Title	Hardware Watchdog Chassis Analysis and Review
Author(s)	R. Abbott, B. Abbott, V. Sandberg, D. Barker, R. McCarthy
Date	30 July 2015

Figure 1

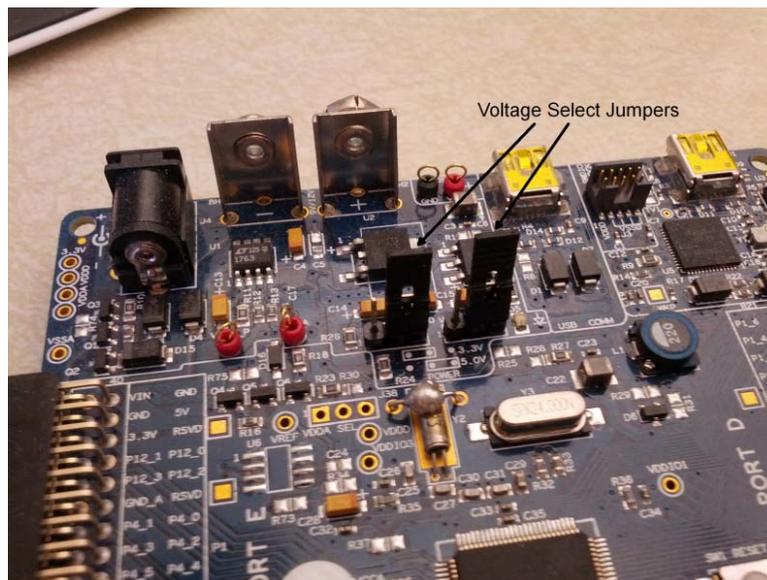
The issue of intermittent booting upon initial power up was reported as only existing in certain units, and only when connected to an operational Satellite Amplifier through the field cabling. Bench testing of S1301701 did indeed reveal the existence of this problem. With a handheld voltage source, a voltage (ranging from 1 to several volts) was applied to the HWWD LED Monitors during boot to simulate the voltage coming from the satellite module. The HWWD was connected to the voltage source through the standard field cabling used at the observatories. The HWWD would not boot properly while the voltage was applied. The problem was traced down to a pair of jumpers on the PSoC board being configured for 3.3V operation, vs. 5.0V operation. The jumpers seen below are in the correct (5.0V) position. All units should be configured as shown below.

After moving the jumpers to the 5.0V position, repeated tests were conducted and no boot issues were seen. The applied voltage was increased to 13VDC and still no boot problems were seen. It is worthy of note that the output impedance of the satellite module monitor channels that feed the HWWD is 4.7kΩ. This series resistance, in conjunction with the 300Ω resistor forming the inverting input of an opamp stage in the HWWD, forms a unity gain stage. The absence of the 4.7kΩ resistor in the satellite module would result in a gross gain error.

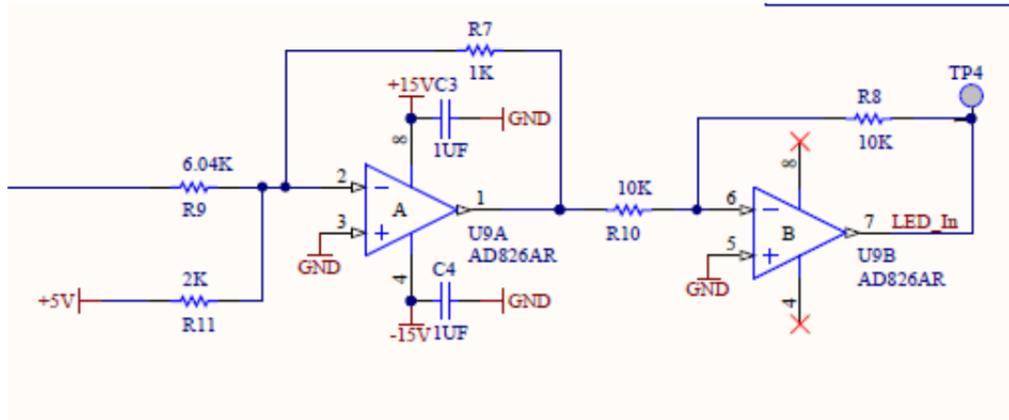
The schematic shown above is an excerpt of D1201549-v3. The component values shown for R7, R9, and R11 are not correct. The correct values are: R7 = 5kΩ, R9 = 300Ω, R11 = 10kΩ. The parameter on the right named “LED_In” is compared internally by the PSoC to a reference voltage (2.640V) as a measure of satisfactory operation of the satellite module LED current monitors. With a nominal current flowing in the OSEM LEDs as driven by the satellite module, the measured voltage present at TP4 is 3.5VDC

Figure 2

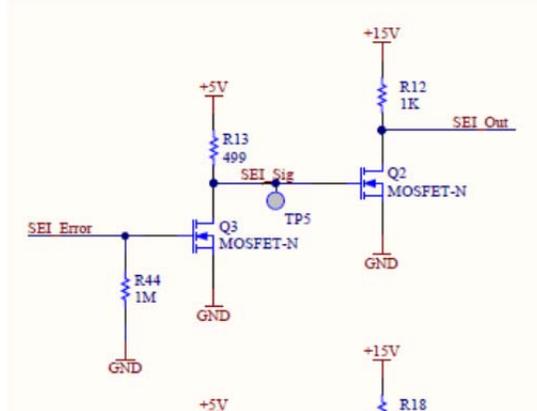
The existing logic monitors for D1201549-v3 are shown below. The left-hand node labeled SEI_Error is at a logic low during normal operation. This logic state creates a logic high at the node labeled SEI_Sig, and a logic low at SEI_Out. SEI_Sig is used to drive a front panel green LED to provide a visual indication of the normal condition. SEI_Out is sent to binary monitors to remotely annunciate the state of the HWWD. It is obvious by inspection that this circuit is not easy to change if the goal is to preserve the functionality of the LED. What is needed would be another logical inversion after SEI_Out such that the normal state is indicated by a logic high voltage level.

A small circuit board (see D1500215-v1) has been built that accomplishes the logic flip. A MOSFET is used in a similar manner to those seen in Figure 2. The overall topology of the circuit board is shown in Figure 3. Power to the MOSFETS is provided from spare DC power supply outputs within the HWWD chassis. This circuit board is small enough to go in line with the existing cabling interior to the HWWD chassis in a plug-and-play fashion.
